# UNITED STATES PATENT AND TRADEMARK OFFICE

10/586,069

<b>Office Action Summary</b>	<b>Application No.</b> 10/586,069	<b>Applicant(s)</b> FUKUSHIMA, SUSUMU	
	<b>Examiner</b> KIMBERLY E. GLENN	<b>Art Unit</b> 2817

## DETAILED ACTION

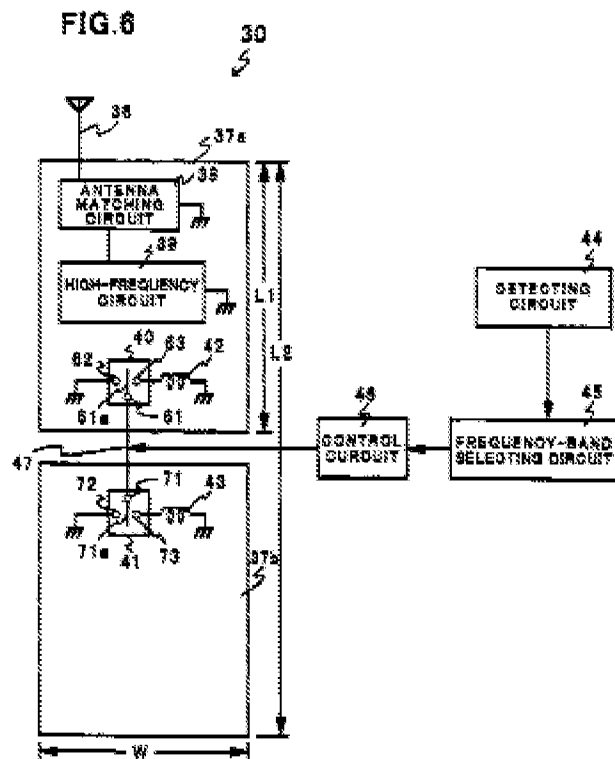
Ueda disclose in figure 6, a cellular phone comprising an antenna 36; a high-frequency circuit 39 connected via a matching circuit 38 to the antenna; a first printed substrate 37a which comprises a first ground section connected to the high-frequency circuit (see paragraph [0085]); a reactance circuit comprising inductors 42 and 43, wherein inductors 42 is connected to the first ground section (see paragraph [0086]); and a second printed substrate 37b which comprises a second ground section connected to the reactance circuit.

The cellular phone, further comprising a frequency band selecting circuit which examiner considers to be a transmitter-receiver; and a cable for connecting between the terminals (62-63 and 72-73) of the switches 40 and 41. The terminals (62, 63) are connected to the first ground section while the terminals (72, 73) are connected to the second ground section as evident from Fig. 6. Therefore, the cable provides connected between the first ground section and the second ground section and the frequency band selecting circuit.

The reactance circuit includes inductors 42 and 43 and a switches 40 and 41 for switching the inductors.

Thus, Ueda is shown to teach all the limitation of the claims with the exception of both the first ground section and the second ground section being formed on a (single) substrate.

It would have been obvious to one having ordinary skill in the art at the time the invention was made to construct both the ground section of Ueda on a single substrate, since it has been held that the use of a one piece construction instead of the first and

second ground planes being constructed on two separate printed circuit boards as disclosed in Ueda would be merely a matter of obvious engineering choice.
